RE: Development Application MCUC 2915/2018, 20 Warner St, Pt Douglas. RFI 18007CL

MICRO HOTEL, 20 WARNER STREET – PORT DOUGLAS
DEVELOPMENT APPLICATION MCUC 2915/2018

RESPONSE TO INFORMATION REQUEST (Council Ref. MCUC
2915/2018(DocID881197) dated 22 Nov.2018 FOR 20 WARNER STREET,
PORT DOUGLAS; LANDSCAPE.

**Re: Development Application MCU for Short-term Accommodation (Hotel)
20 Warner Street, Port Douglas**

Dwg no:
LS_02

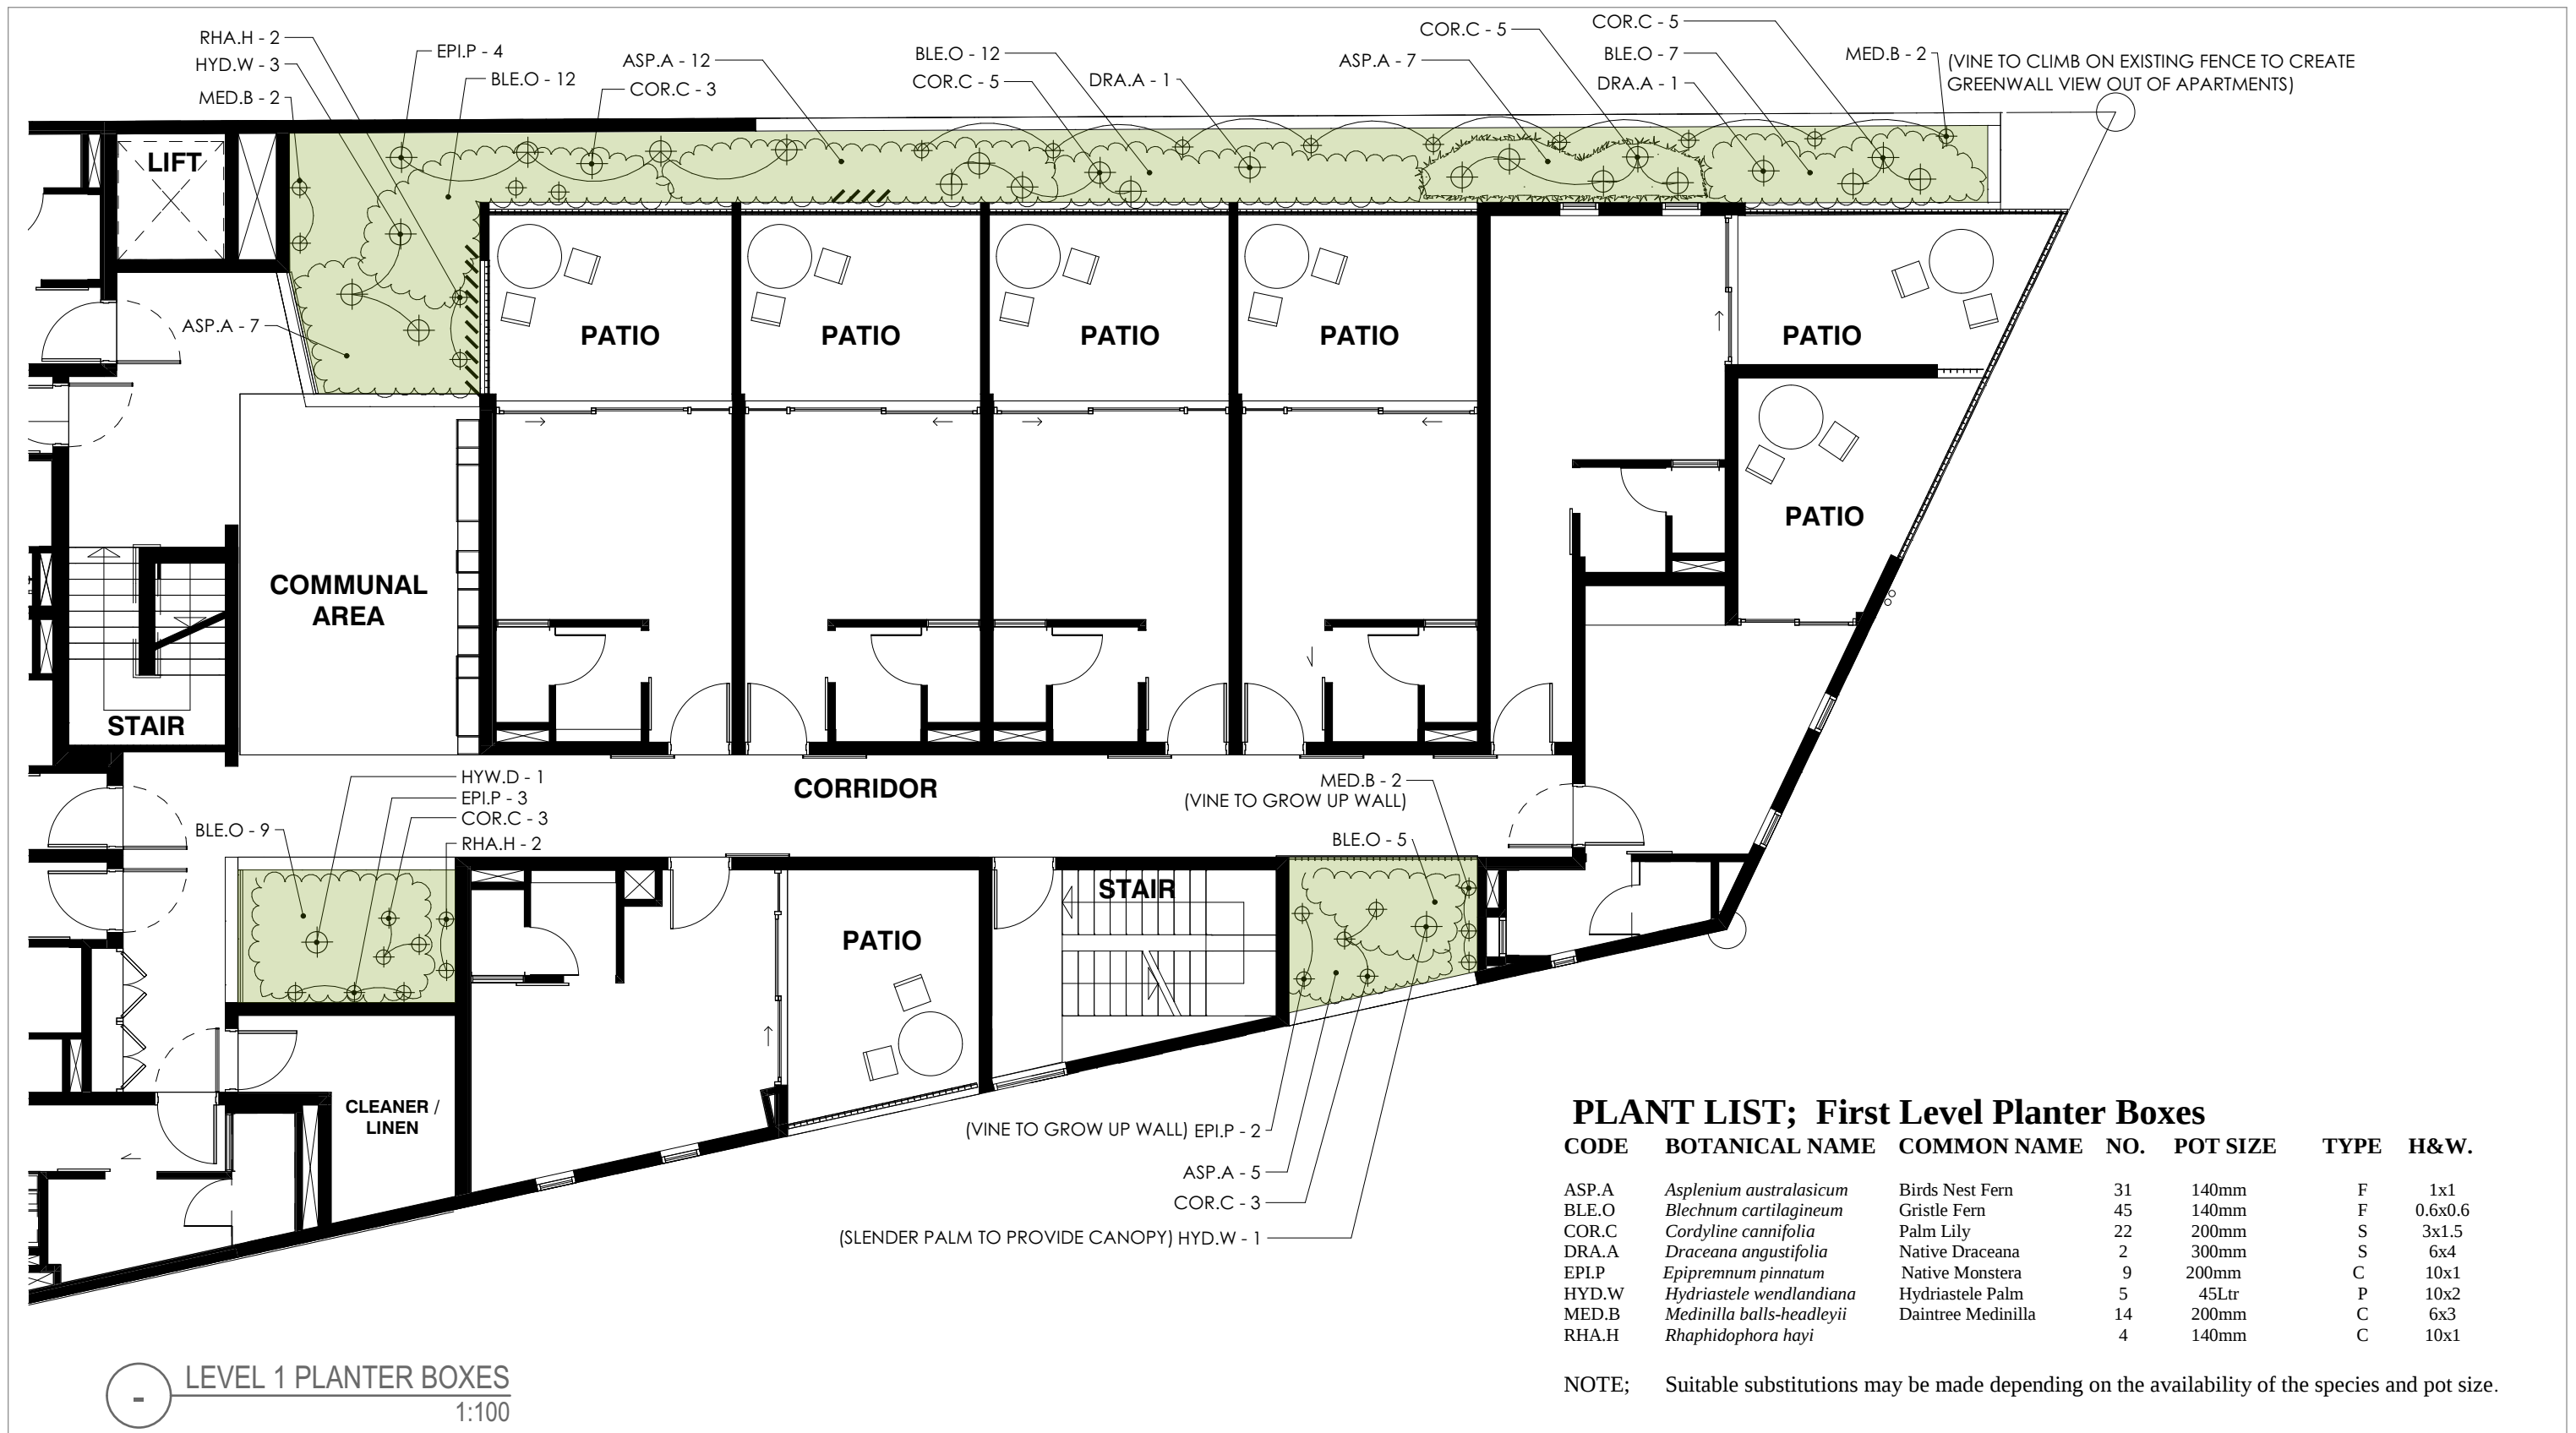
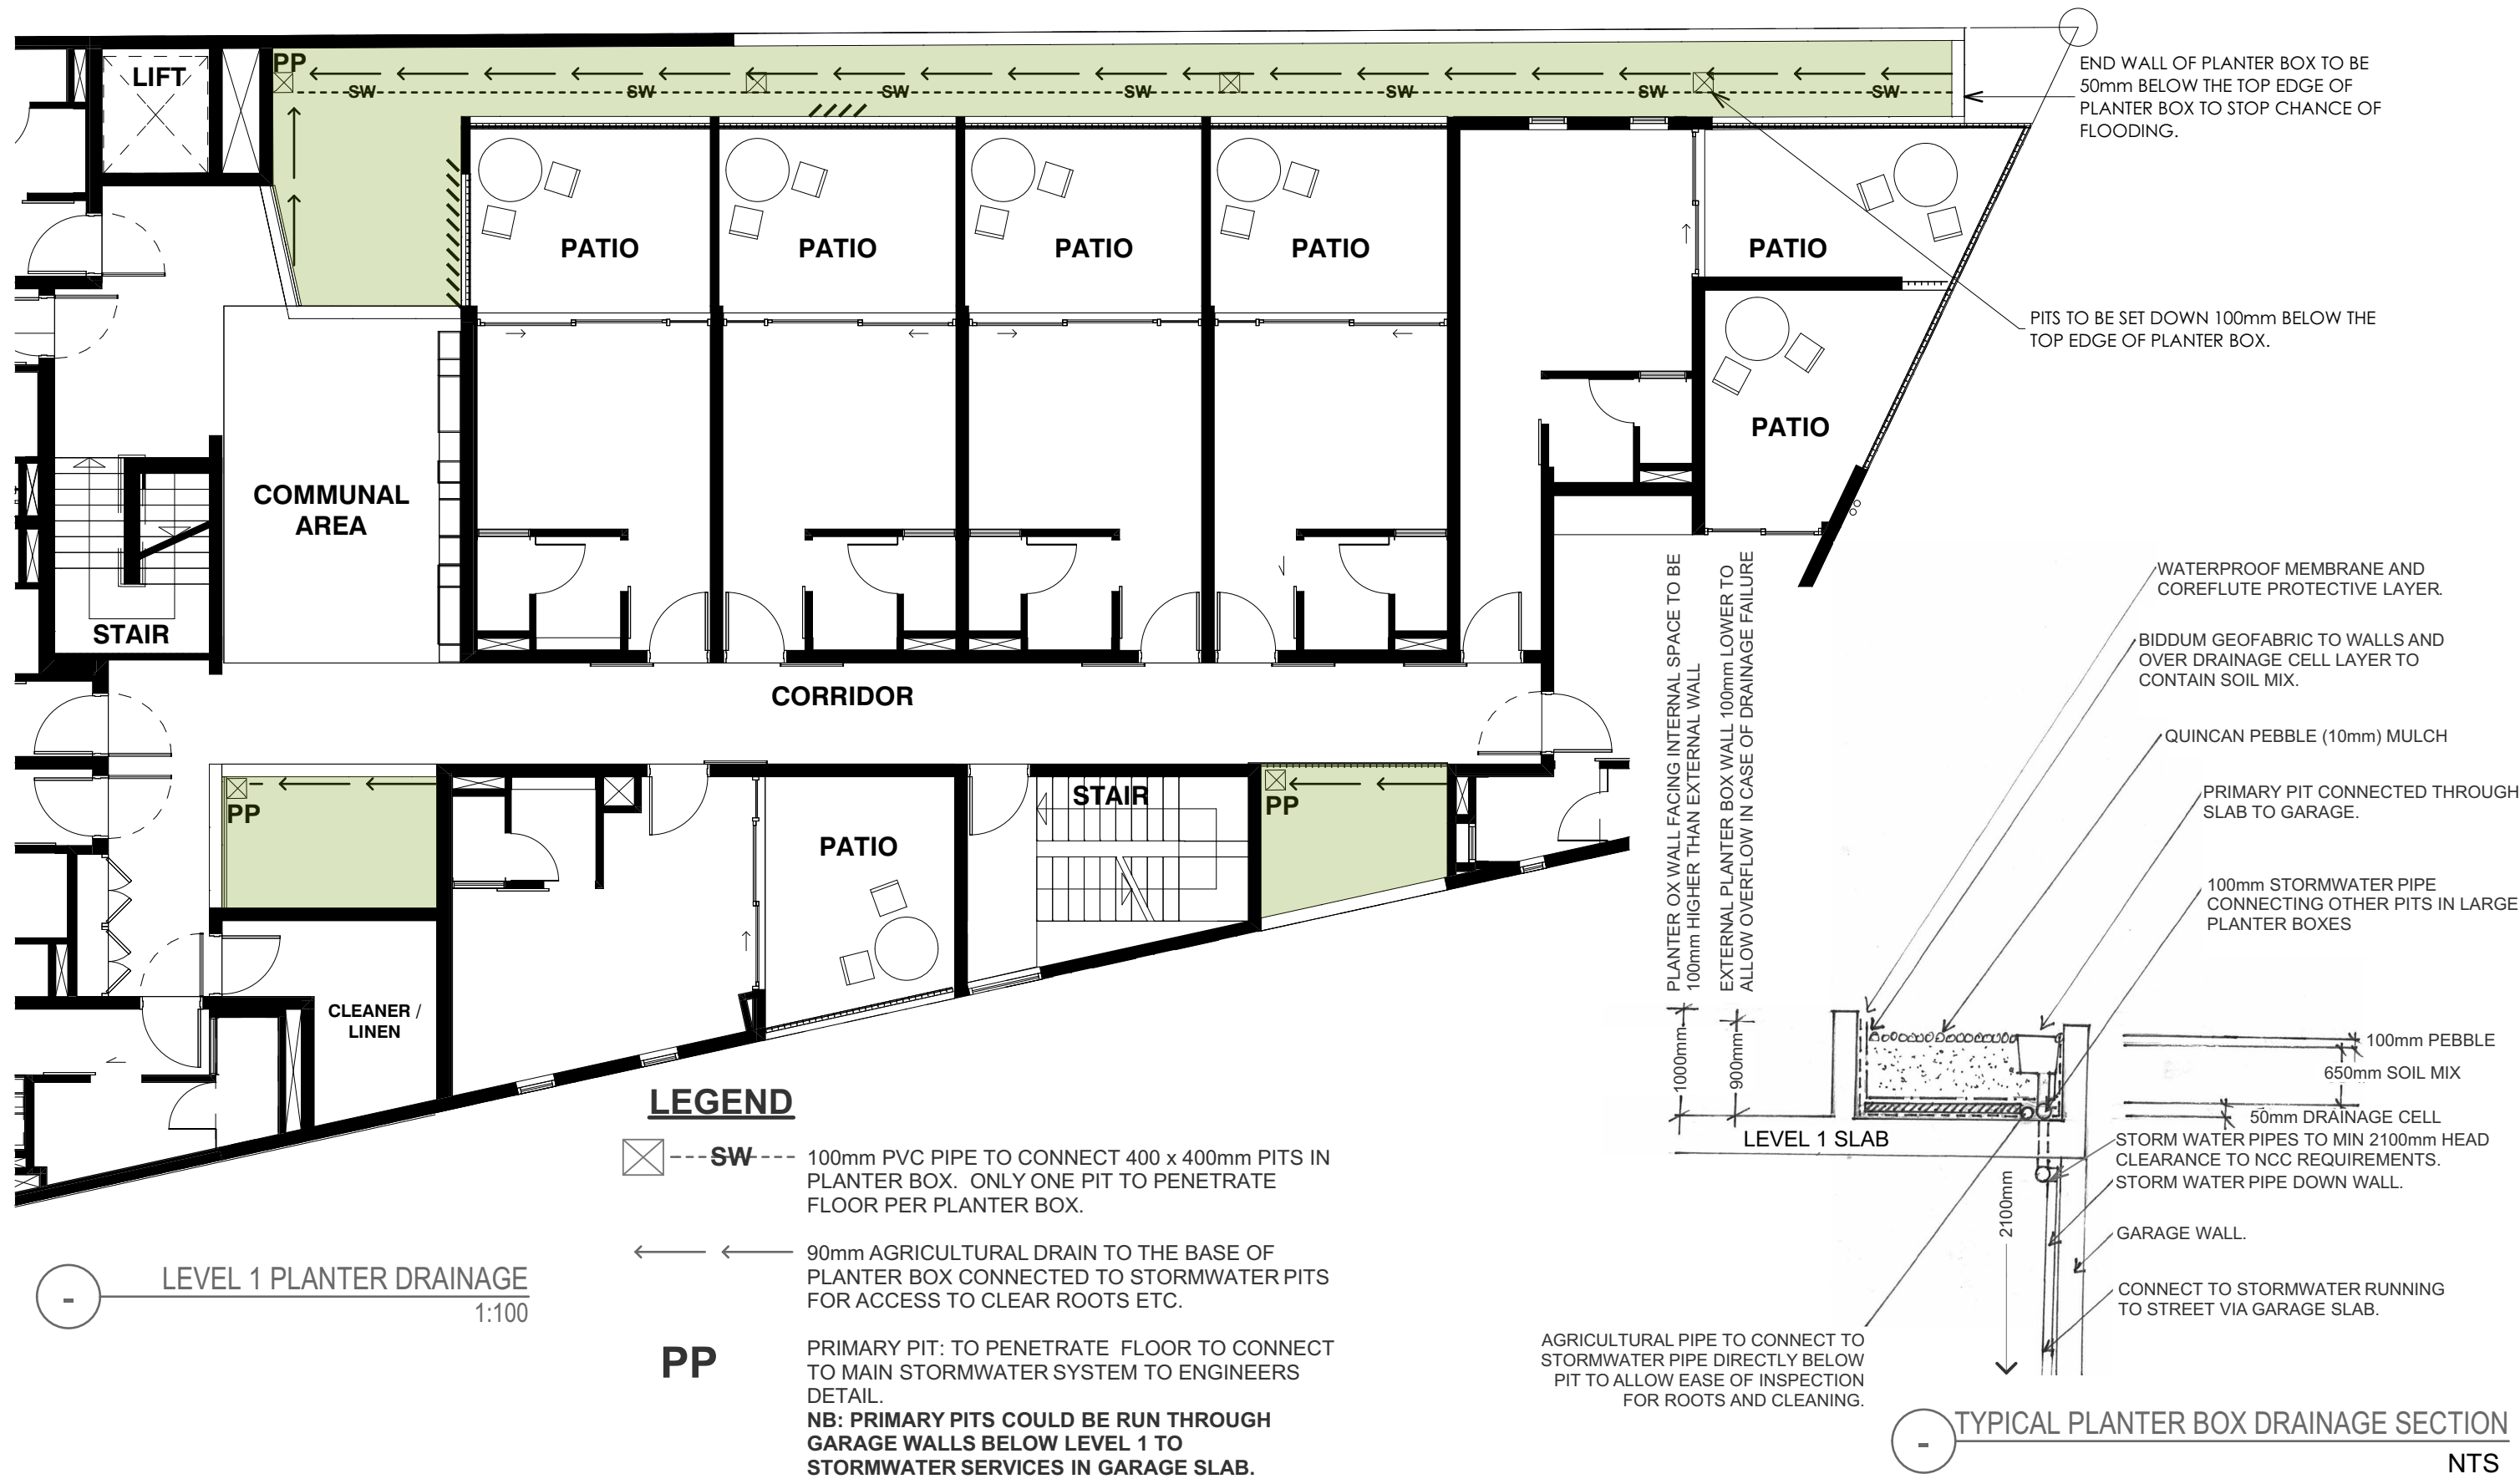
Information Requested	Response
8. Landscape Plan a. Please clarify what the proposed plants are in the street island planting areas detailed as “CAR.P” on the Hortulus Plan, Page 1 of 1.	The consultant landscape architect has provided further information on the details of the planter boxes, including sections and drainage details. Refer to Appendix 4 for further detail.

8a. Please see the revised Landscape Sheet LS_01. The notation "CAR.P" has been corrected & now reads "GAR.P" for *Gardenia psidioides*.
